6K VRRT Forklift...

ATLAS cylinders are too short for 6K VRRT forklift

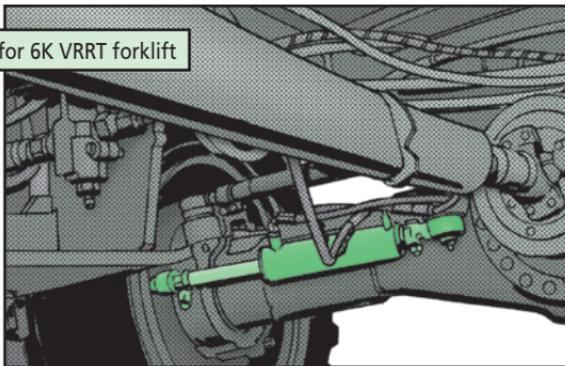
I'm really scratching my head on this one. Our unit needed new steering cylinders for the MHE 269 6K variable reach rough terrain (VRRT) forklift. So I ordered the cylinders listed as Items 1 (NSN 3040-01-454-3531) and 4 (NSN 3040-01-454-3533) in Fig 127 of TM 10-3930-660-24P (Aug 12).

When they came in, the cylinders were two inches too short! In fact, they appear to be the ones used on the 10K ATLAS forklift.

Can you help us out with the right NSNs for these cylinders?

You're right. Those are the ATLAS cylinders. An error was made when the 6K forklift's parts manual was updated.

The 6K VRRT forklift's left-front and right-rear cylinder comes with NSN 3040-01-294-3441. Get the right-front and left-rear cylinder with NSN 3040-01-593-8783. Make a note until the TM is updated.
